REMARKS

Applicant notes with all due appreciation that prosecution on the merits is closed and that the application is in condition for allowance except for formal matters. These are addressed in this paper. Following is applicant's response to the numbered sections of the Office communication using the same numbering:

OIPE Buoncuore
Brawing Change Request

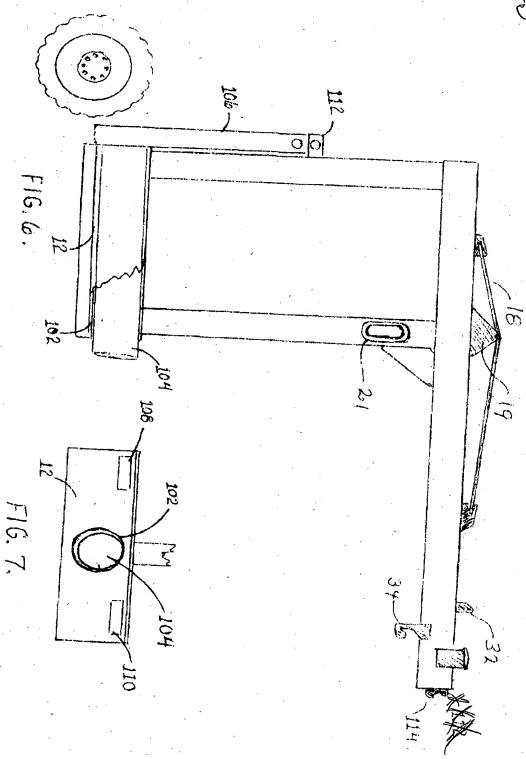
- 3. The following formal matters have been addressed as noted:
 - in the drawings, the examiner objected to reference character "112" being improperly used to designate both "ears" and "shackle". In Figure 6 applicant requests permission from the examiner to alter the drawing by deleting the redundant "112" referencing improperly the shackle. This "112" is shown crossed out in red on one sheet submitted herewith. A corrected sheet with that change is submitted also. So that the text will agree with the drawing, applicant, by amendment above, has in line 13 of the insert previously added to page 5 of the specification deleted "112" and replaced it with "114". The as-filed figure 6 is antecedent basis for this correction of the text"

- in line 2 of the insert added to page 3 of the specification because "warp" should be -wrap--. This mistype was corrected by amendment above;
- in the insert added to page 5 of the specification, reference numeral "112" was used to designate both" ears" and "shackle". This has been corrected by amendment above and Figure 6 has been conformed with permission to delete the redundant number requested above;

- Approval of the proposed drawing correction is noted. A corrected drawing is included with this amendment. This is the sheet bearing Figures 5A – 5D
- 2. The examiners entering of applicant's election of species without traverse is noted.
